# Objections to the Drawings

## Claim Rejections Under 35 U.S.C. §112

FIG. 1

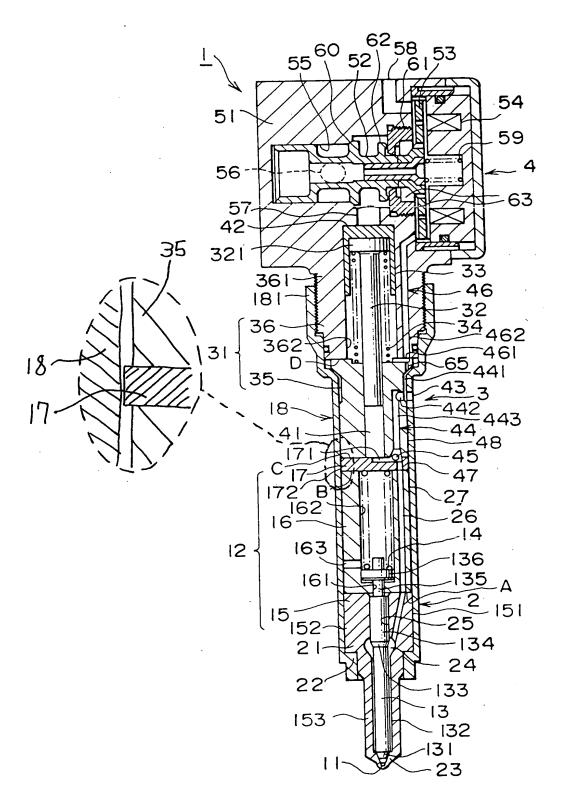
1. The drawings were objected to under 37 C.F.R. 1.83(a) for not showing the "enlarged diameter" as recited in claim 1. Figure 1 is submitted contemporaneously, with an accompanying separate paper. Figure 1 has been amended to show an enlarged view of the "enlarged diameter" as recited in claim 1. No new matter has been added. Thus, this grounds for objection has been rendered moot. Additionally, Figure 2 has been amended to remove an incorrect demarcation (number 42) and to properly extend the lead line for element 32. Figure 2 is also submitted contemporaneously, with the accompanying separate paper
